ADDENDUM NO. 1

Schertz Seguin Local Government Corporation

Contract 3 - 36" Pipeline

October 27, 2020

DRAWING NO. **C115**

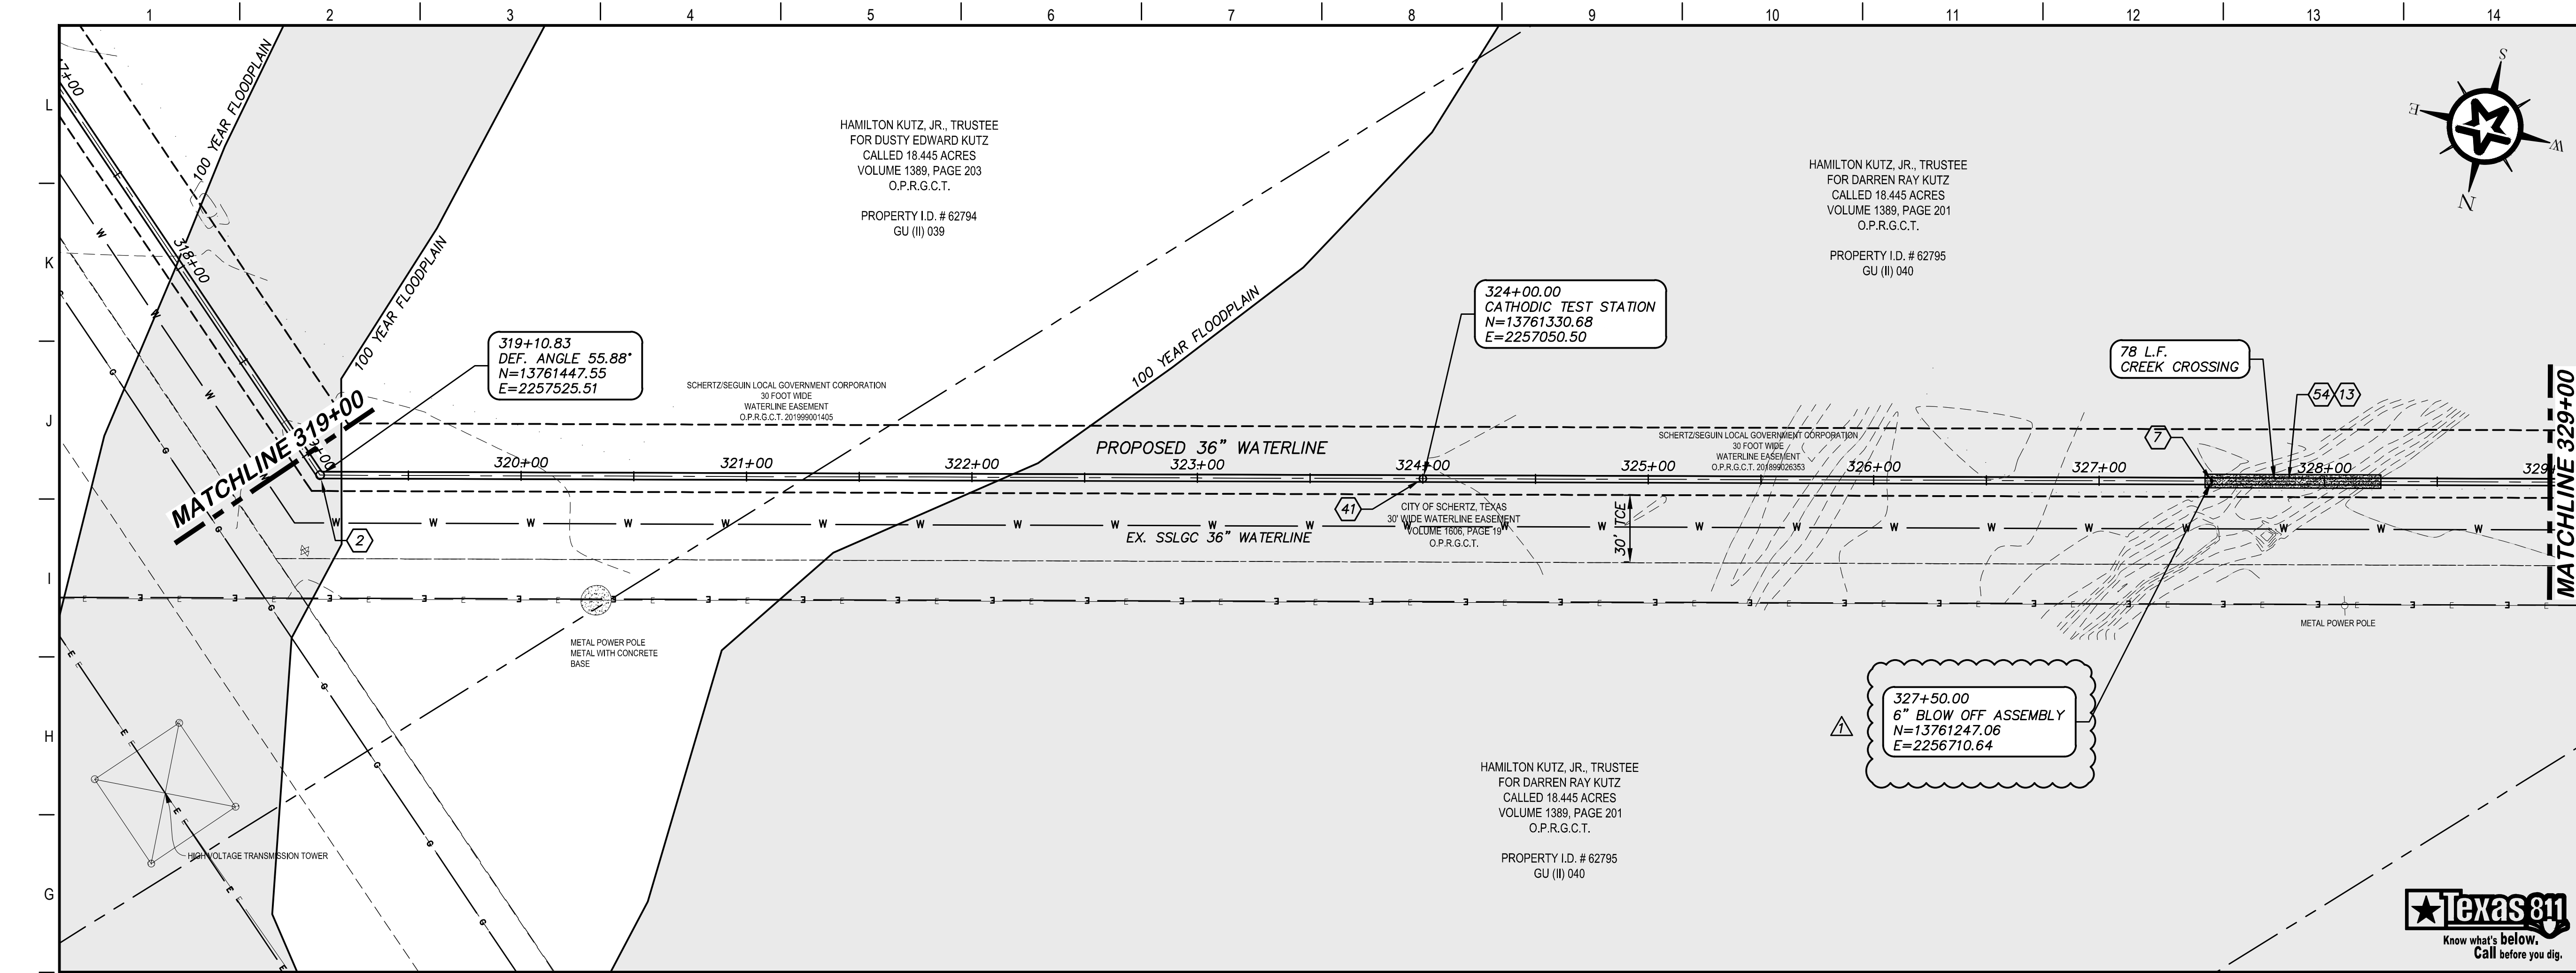
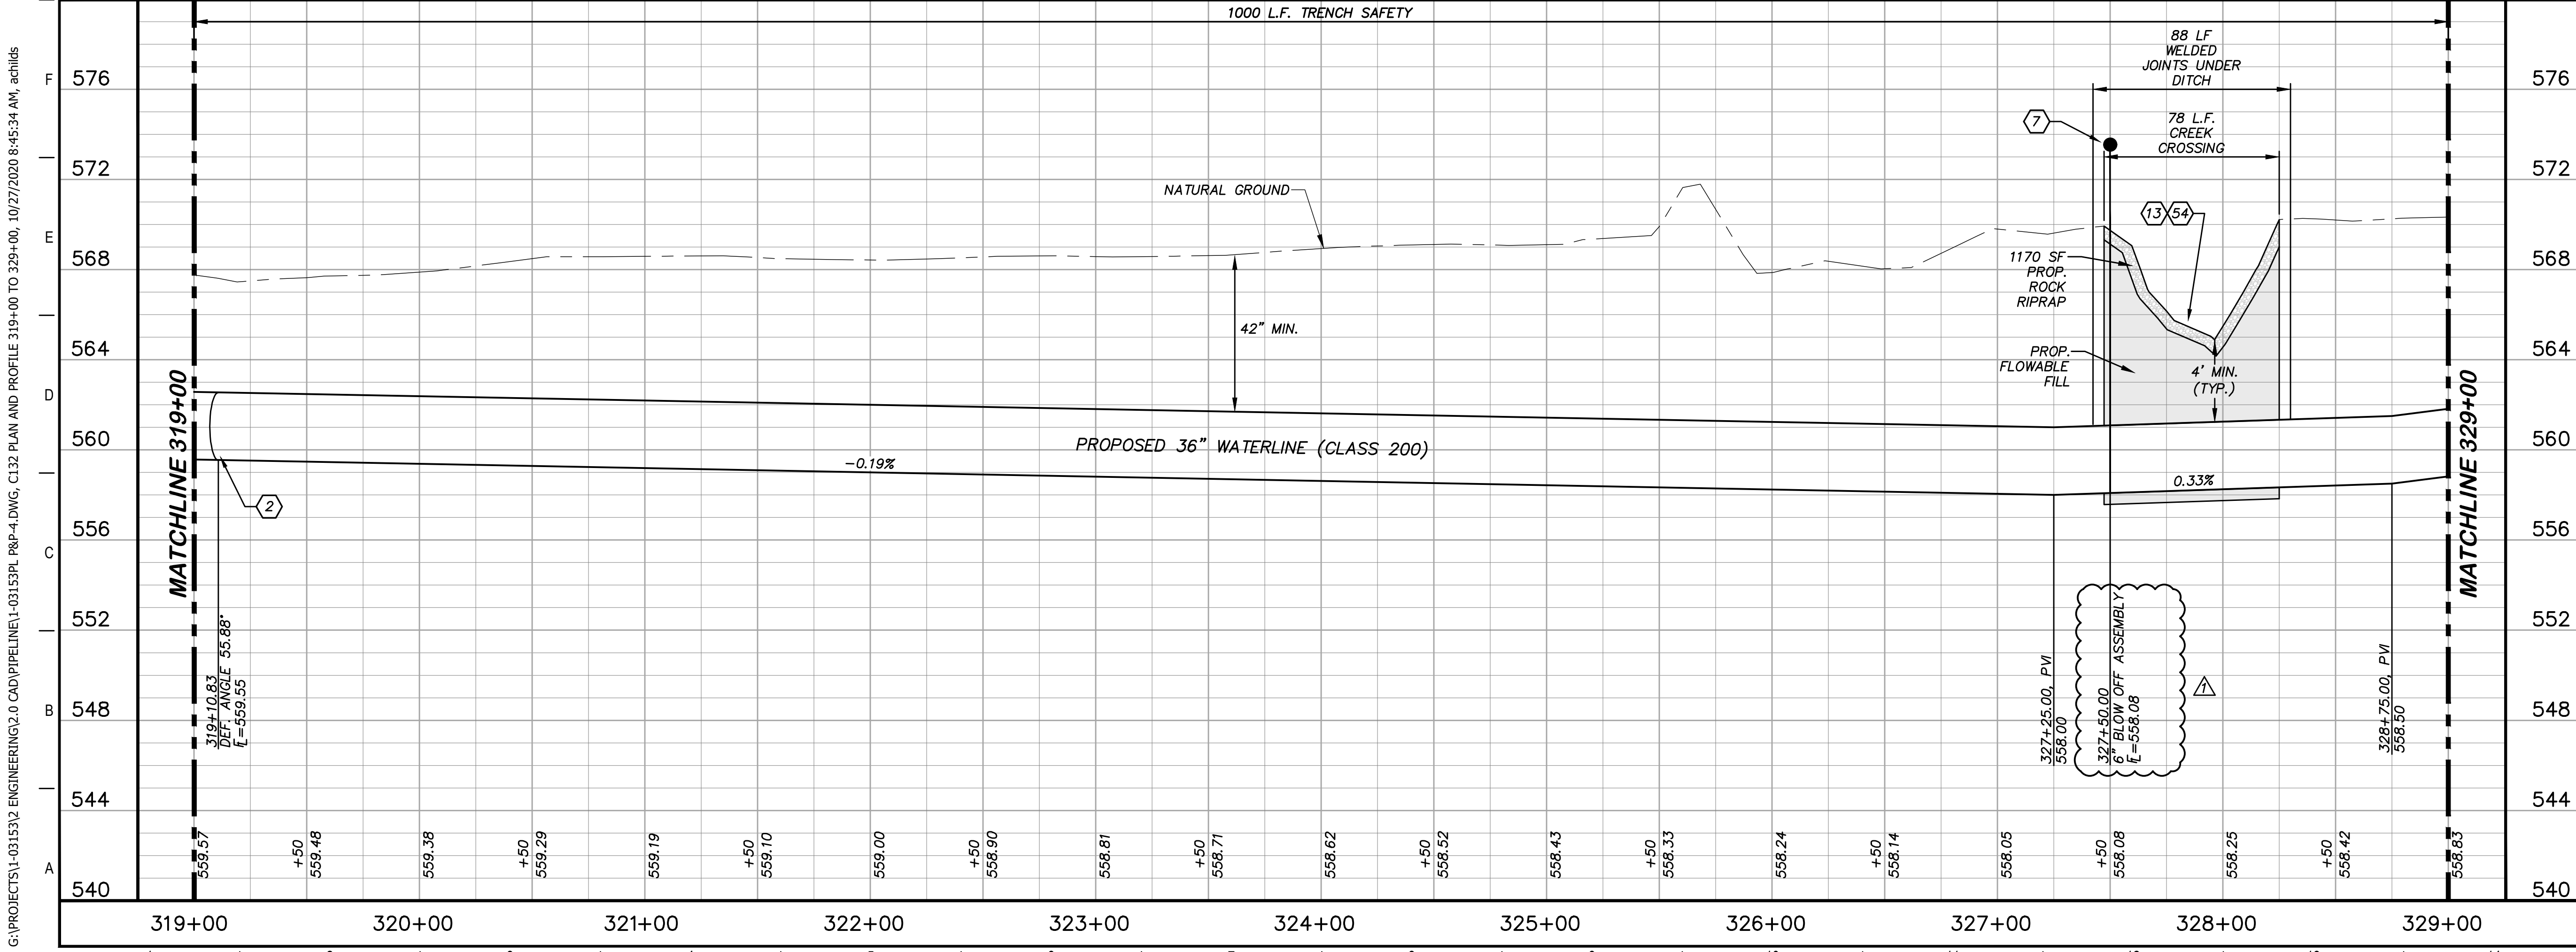
3. Sheet C115. Bore crossing under I-10 is hereby amended per TXDOT approved permit requirements. Use the attached sheet for this Project.
4. Sheet C132. Blow-off valve assembly added at Station 327+50.

DESIGNED	JFW
DRAFTED	ARC
CHECKED	JFW
PROJECT NO.	1-03153
DRAWING NO.	C145

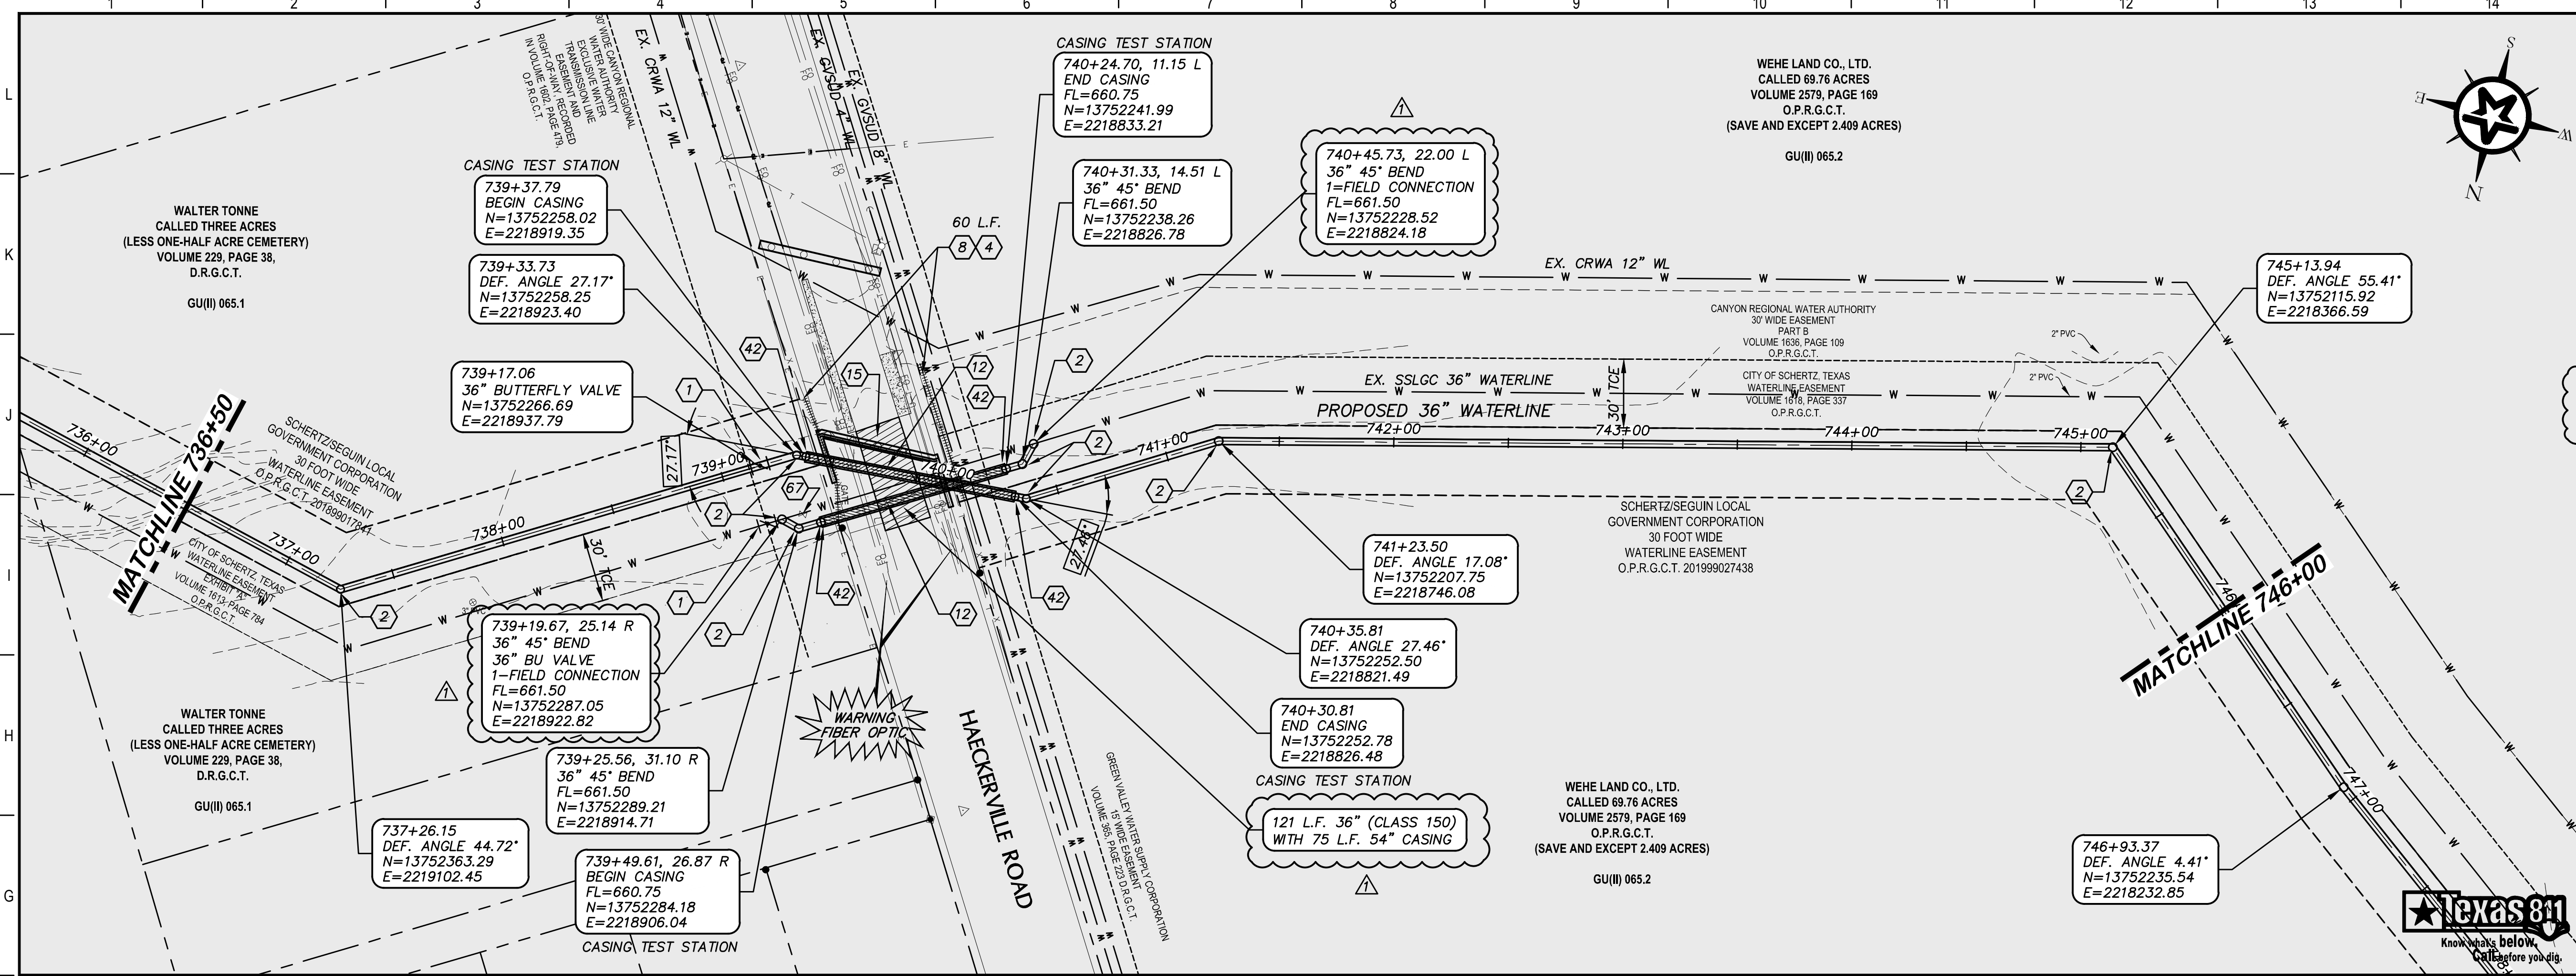
5. Sheet C114. Profile of pipeline is amended to accommodate the Air Valve Assembly. Use the attached sheet for this Project.
6. Sheet C145. Flowable Fill above casing deleted.
